GeoShield Verification Report 1

GEO105226

European Screeding Ltd
New School Building, North Huddersfield Trust
School,
Woodhouse Hall Road,
Huddersfield,
HD2 1DJ

New School Building - Infills

New School Building - Perimeters

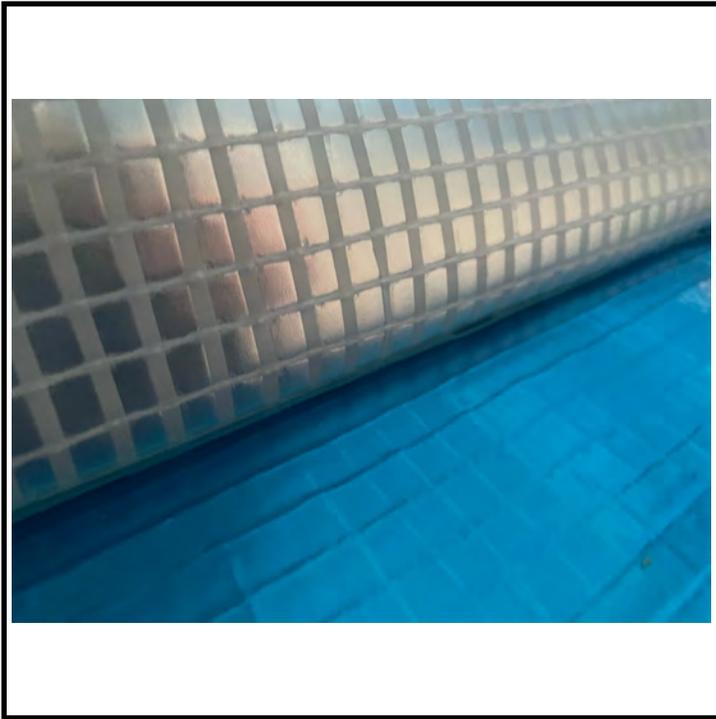
The perimeter membrane had already been installed and brickwork built up prior to European Screeding entering site therefore, GeoShield were unable to verify the installation of Visqueen Ultimate DPC to the perimeters.
